INFORMATION DISCLOSURE STATEMENT

DRAWINGS

FIG. 1

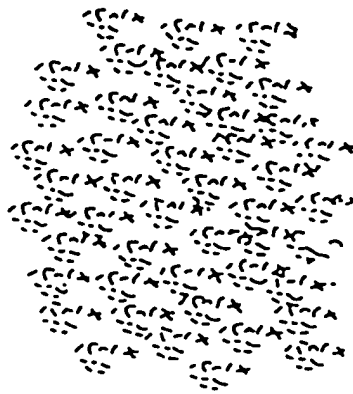
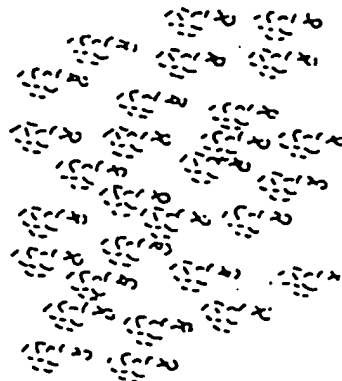
The Patent Office objects to the drawings filed, because they fail to show the deployment of the invention (Figure 1, Stage 1), which states that the invention is deployed from the aft deck of a ship (page 5, lines 6-7), as described in the specification. Applicants submit that any structural detail that is essential for a proper understanding of the invention specified in the claims is shown in the drawings in accordance with 37 CFR §1.83(a), and provides the following explanation. With respect to Applicants' specification, page 5, lines 6-7 which state "[T]hese devices are thrown to a distance from the aft deck P of a ship," these structural details are shown in Figure 2. At the top of the treelike structure in Figure 2, is a top view of a ship and a circle including the aft end of a ship which is shown in Figure 2 in the exploded view of aft deck P including two launcher locations for throwing decoys in directions identified by the arrows. Such launchers may include typical launching devices known in the art and are not included in the current claims. Thus, the Applicants assert that with respect to Figure 1, Stage 1, that Figures 1 and 2 are in accordance with 37 CFR §1.83(a) and MPEP §608.02(d).

The Patent Office also objects to the drawings as not showing every feature of claim 1, as required by 37 CFR §1.83(a). In response, the Applicants have corrected Figure 1, Stage 2 to show the body of effervescent material, as well as a covering material that is soluble in sea water. The Applicants assert that no new matter has been entered as the corrected drawing is fully supported in the specification, as follows. A covering of material that is soluble in sea water for covering and effervescent material and having a thickness is described in Applicants' specification on page 1, line 18 and
